LTR. W/ATTACHED RE OUR 4/12/76 LTR.....
FURNISHING REQUESTED INFO. RE POTENTIAL
CRACKING IN REACTOR FEEDWATER NOZZLE BLEND
RADII.

Re: Nine Mile Point Unit 1
Docket No. 50-220
DPR-63

Niagara Mohawk Power Corporation
Information Concerning Potential Feedwater Nozzle Cracking
Nine Mile Point Unit 1

FIGURE 1

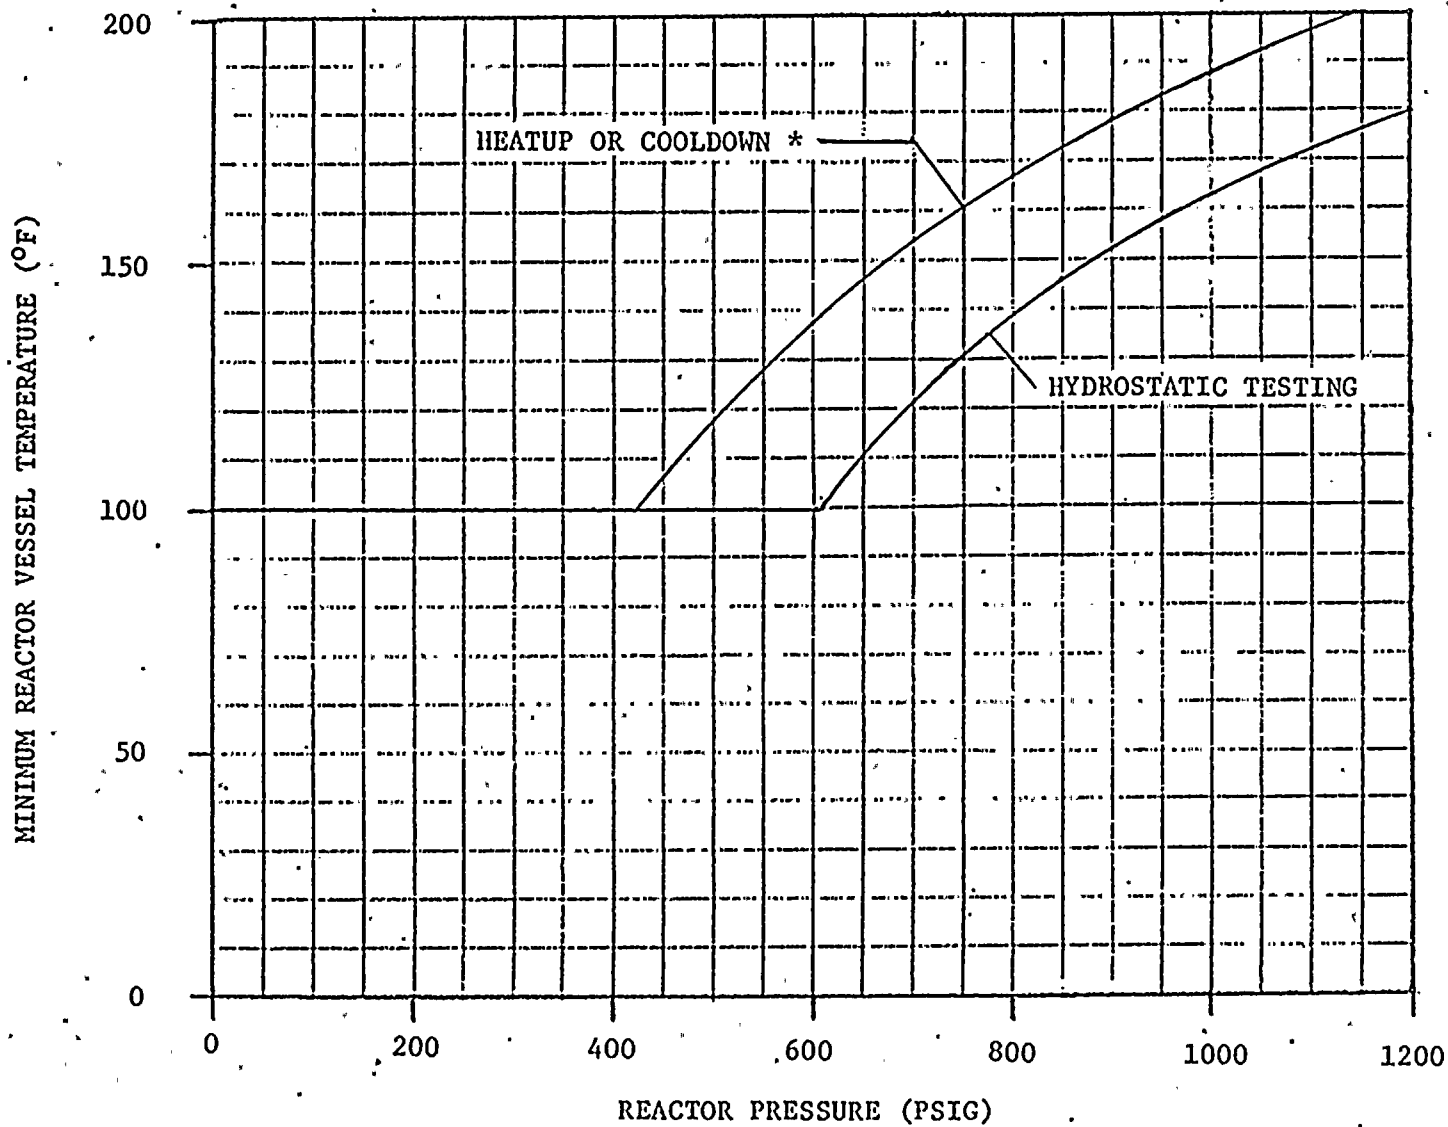
Describe reactor pressure vessel pressure-temperature limits for operating conditions and especially for the inservice-hydrostatic and leak tests.

Reactor pressure vessel minimum temperature limits as a function of reactor internal pressure have been calculated for hydrostatic leak tests and power operation based on postulated feedwater nozzle flaws, as discussed below. Operating procedures are being developed to implement these limits, which are shown in Figure 1.

Minimum pressurization temperatures were calculated using the criteria of Appendix G of Section III of the ASME Boiler and Pressure Vessel Code, (1974 Edition, Winter 1975 Addenda) and the following conservative bases:

1. A postulated flaw size of 2-inches deep was assumed. This value is slightly greater than the $1/4 T$ reference flaw size recommended by the Code and is significantly greater than would be expected based on crack growth analyses and ultrasonic examinations.

2. The A336 nozzle forging material was assumed to have an RT_{NDT} of $+40^{\circ}F$. This value is the maximum value permitted by the vessel procurement specification and is greater than would be expected for this forging material, particularly in the region from the nozzle surface to the $1/4 T$ point -- the location of the postulated flaw.

3. Pressure stresses and stress intensity factor, K , were determined using data presented in Welding Research Council (WRC) Bulletin 175, "PVRC Recommendations on Toughness Requirements for Ferritic Materials." Figure A5-1, for a 2:1 bi-axial stress field. (These data are more conservative than those recommended in WRC 175 for nozzle corner flaws.)

4. In applying the criteria of Appendix G of Section III, it was conservatively assumed that the total peak pressure stress is primary, while in fact, the total pressure stress includes secondary and peak stresses as well as primary stresses.

MINIMUM REACTOR VESSEL TEMPERATURE
FOR HYDROSTATIC TESTING AND HEATUP OR COOLDOWN
